**PUR-1270  
ADDENDUM NO. 4  
INVITATION TO BID**

**CONOCOCHEAGUE TREATMENT PLANT ENR UPGRADE**

**DATE: Thursday, May 19, 2016**

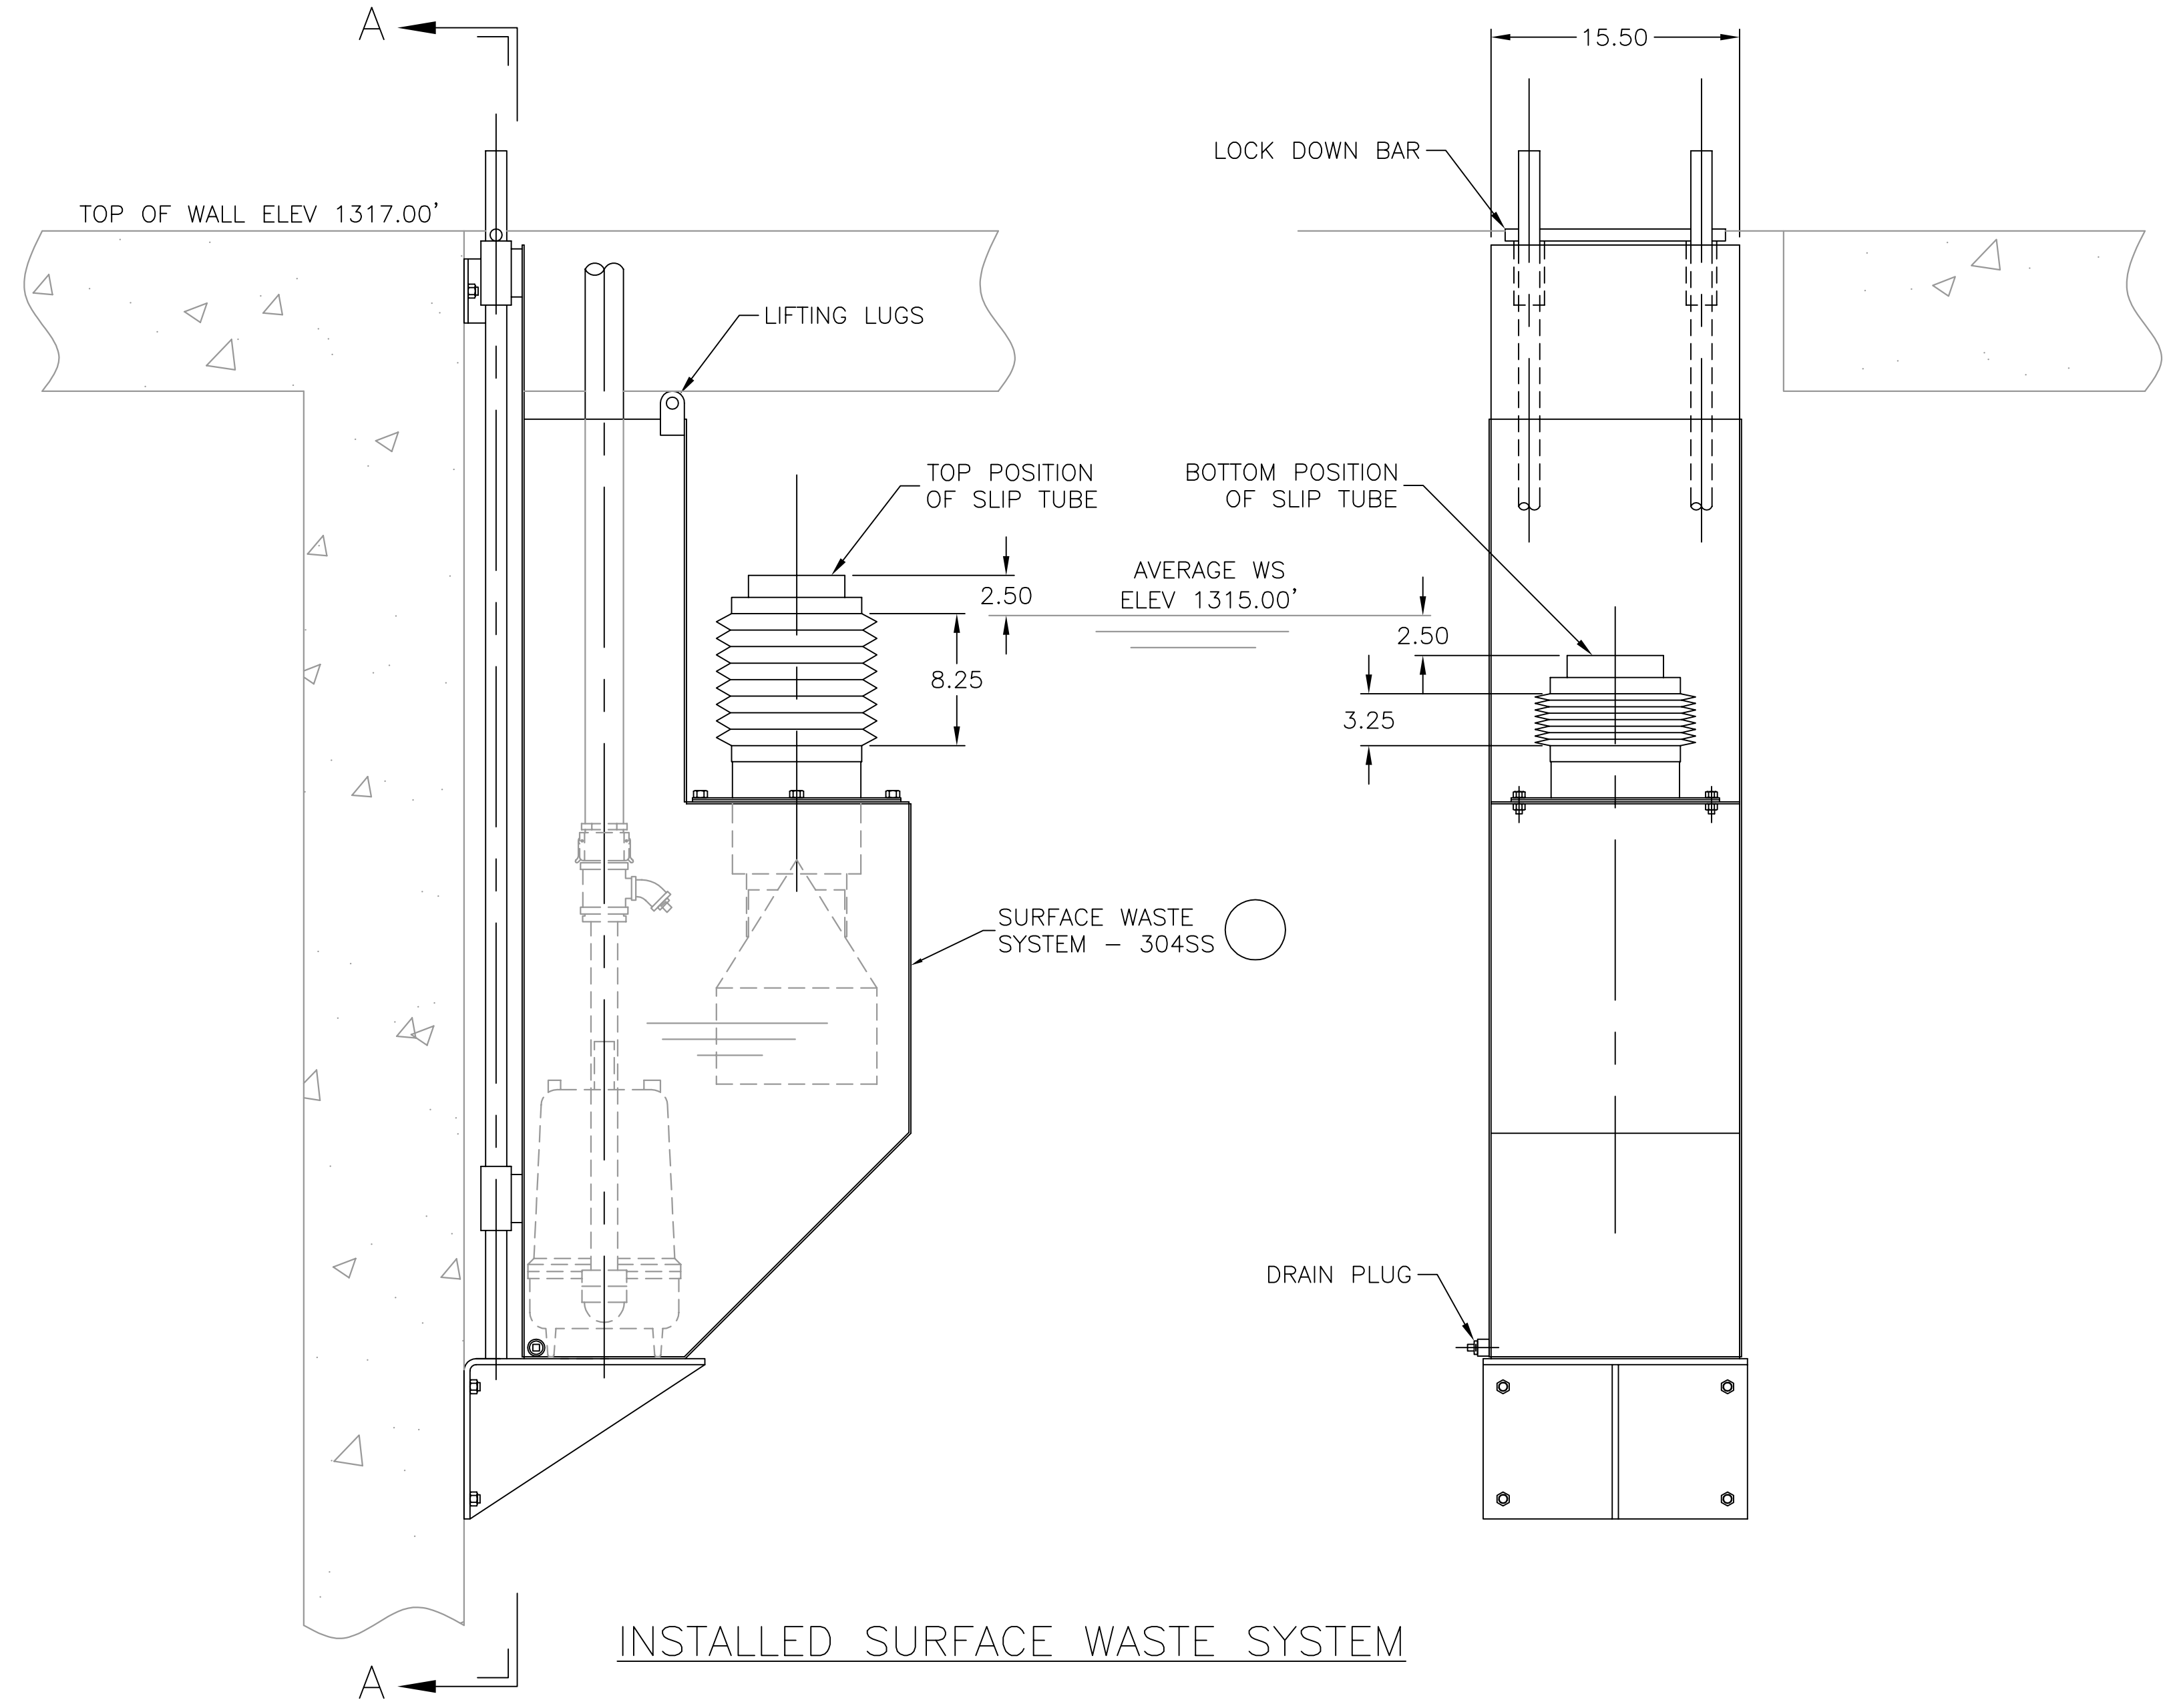
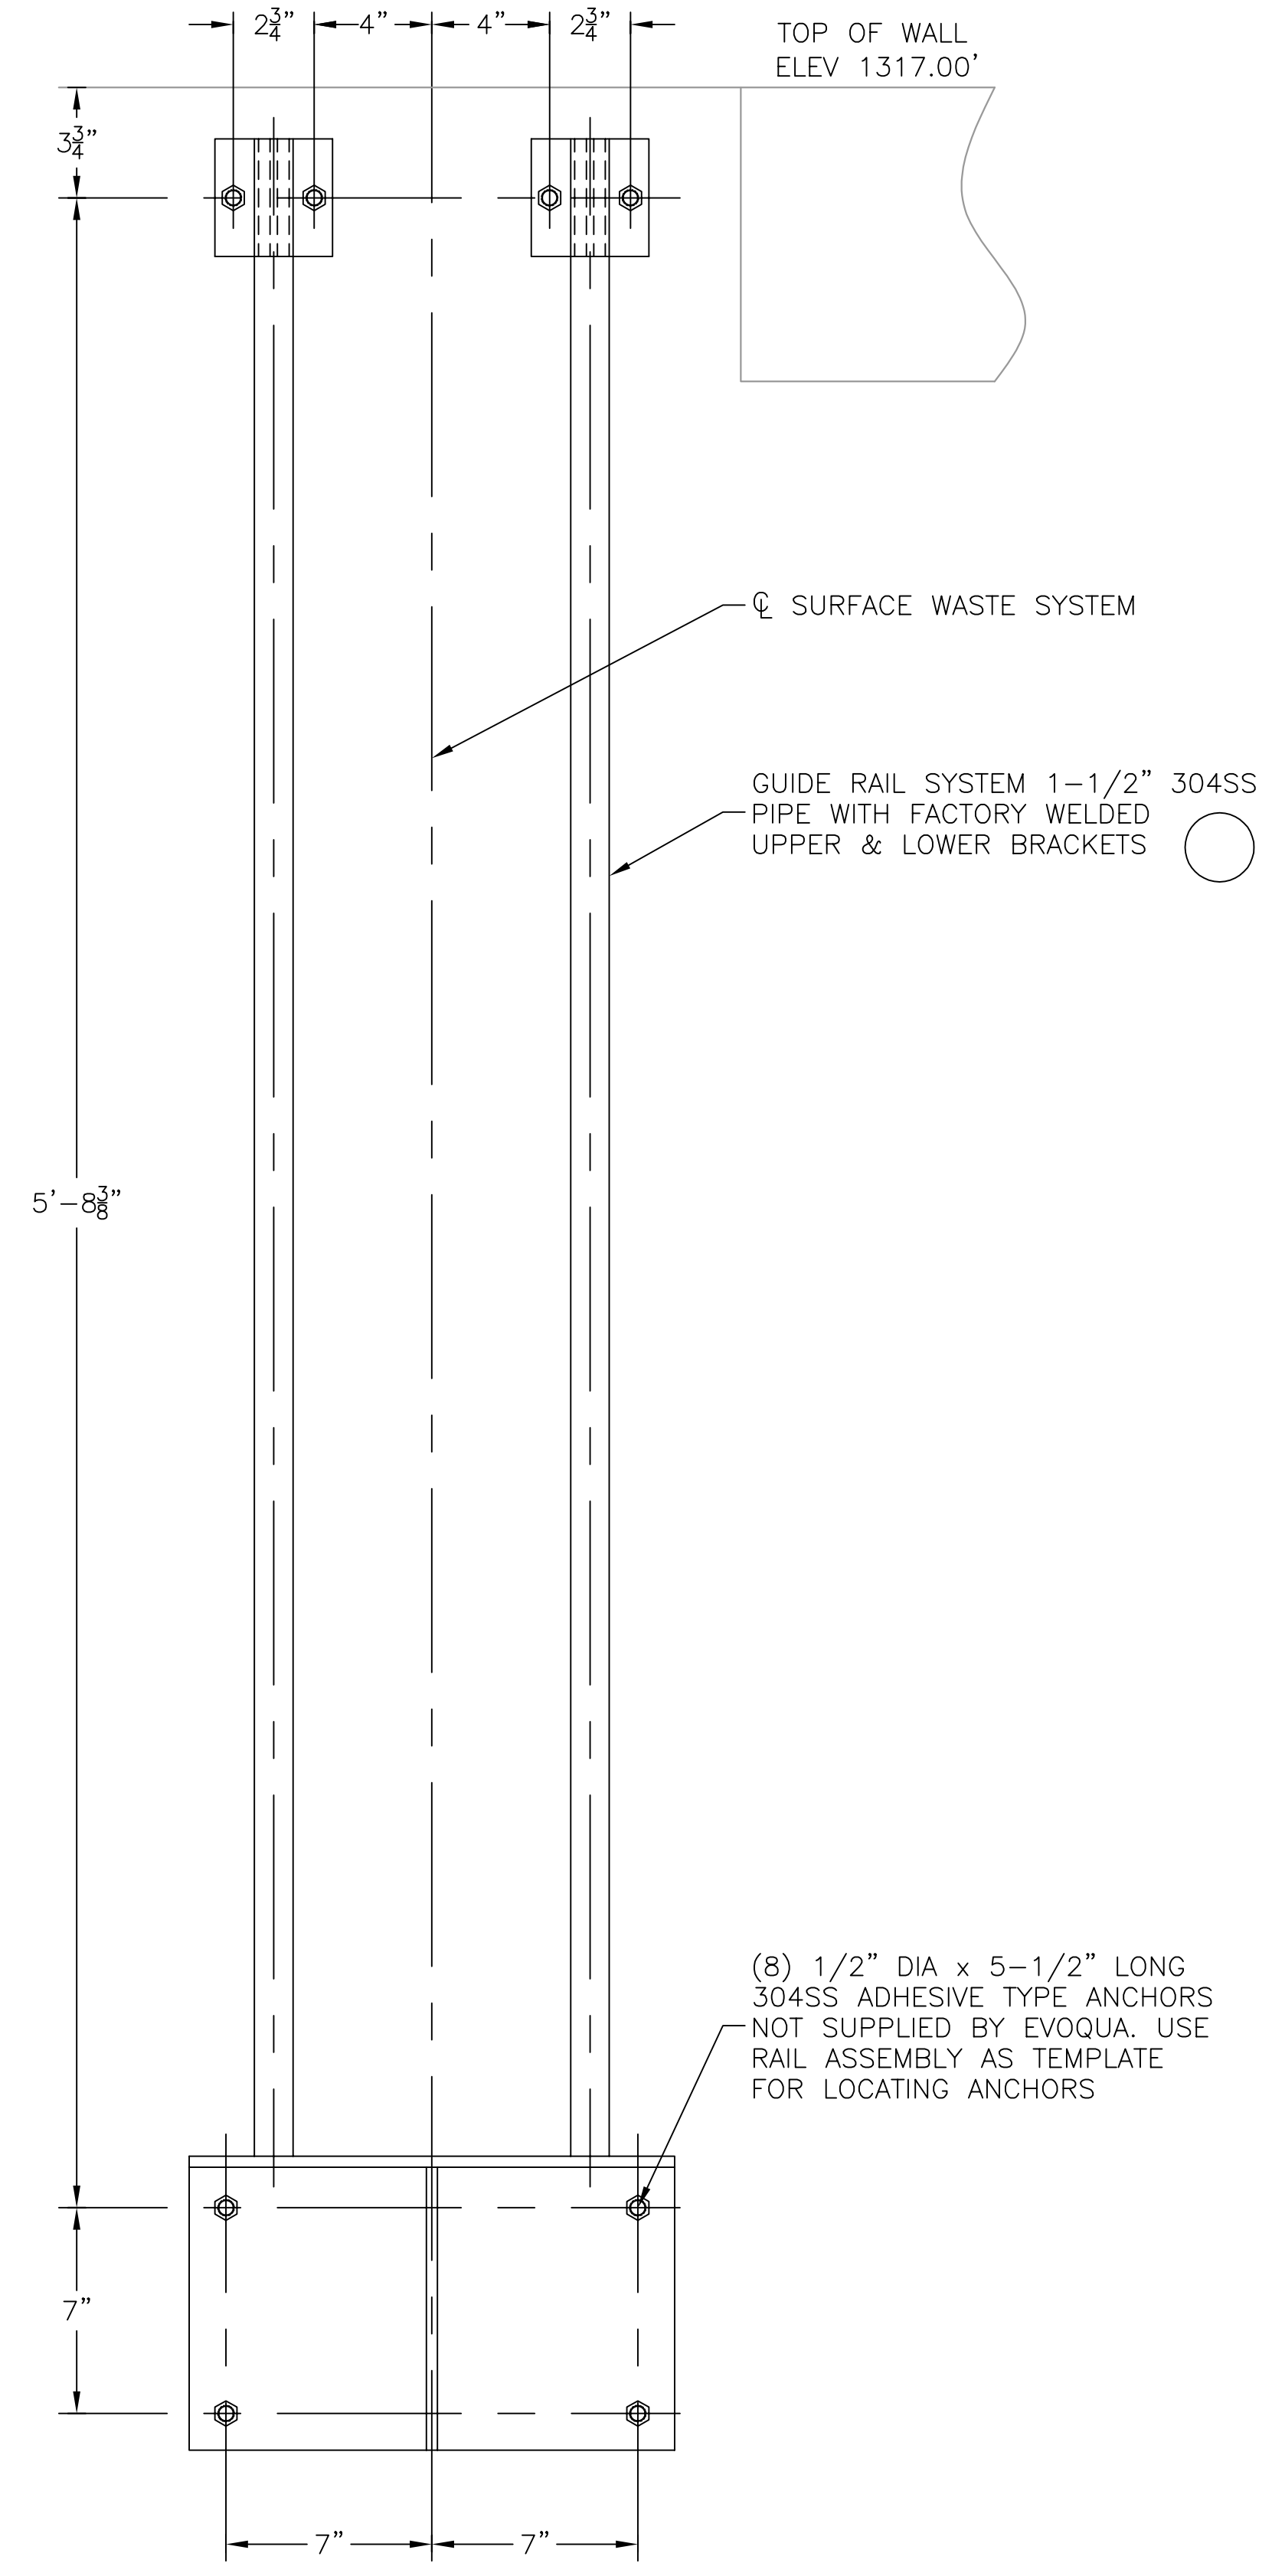
**ITEM NO. 54:** *Inquiry:* In Appendix A on Evoqua’s scope are (3) Surface Waste Pumps (P-310, P-320, P-330). I assume these are the “Surface Wasting Units” called out on section C on drawing PM-20. Please provide mounting details as the “depiction” on section C is not descriptive enough to discern what is required.

*Response:* The surface waste pump is included as part of the surface waste unit. The shop drawing provided by Evoqua for the Winebrenner project has been attached to this addendum for reference and bidding purposes only (drawing 45147-104). Approved shop drawings will be provided to the winning Contractor as they become available.
